**ザンビア「電力アクセス向上事業」
・ ブータン「地方電化事業」の
CDM 事業登録能力向上支援**

最終報告書

独立行政法人
国際協力機構 (JICA)

Figure B.2: Monitoring organization chart for the project activity

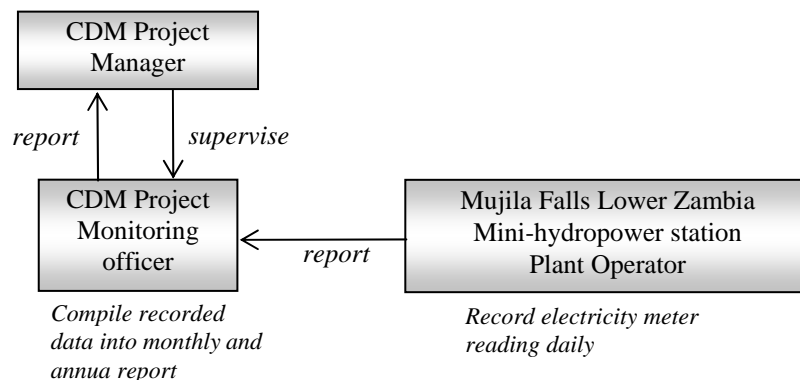
B.7.2 Description of the monitoring plan: Monitoring organization chart	No figure of monitoring organization chart	Figure B.2 for monitoring organization chart is added.	CL-18
C.1.1 Starting date of the project activity	August 2012	28 February 2013	Revised based on the revision of expected date of purchase contract of main equipment
C.2.1.1 The starting date of the first crediting period	01/08/2014	01/03/2015 or the actual starting date of the project operation, whichever is later	“Guidelines on completeness check of request for registration” EB48 Annex60

Figure B.3 Location of monitoring meter

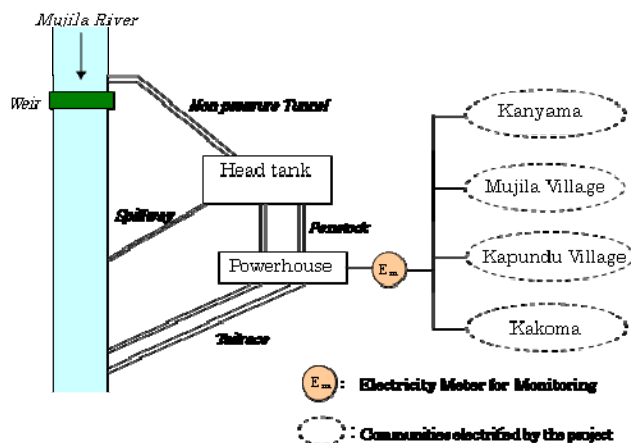
B.6.3 Project emissions	No mention of PE by diesel engine generator	Project emissions taking diesel engine into consideration	CAR-4
B.7.2 Description of the monitoring plan: Location of monitoring meter	No figure of location of monitoring meter	Figure B.3 is added for clarification of location of monitoring meter.	CL-17

33kV T/L MWh meter (E_m) will record the distributed energy. At the time of electricity meter failure, data log accumulated in the computer at Mujila Power Station will be used as the backup. During normal operation, signals of CT (Current Transformer) and VT (Voltage Transformer) will be sent to both electricity meter and to the computer at Mujila Power Station. Signals sent to the computer are kept as the data log. This data log is the duplicate of the electricity meter readings and can be used to calculate distributed electricity during the event of MWh meter failure. Since CT and VT are not electronic equipment, failure of CT and VT are rarely anticipated.
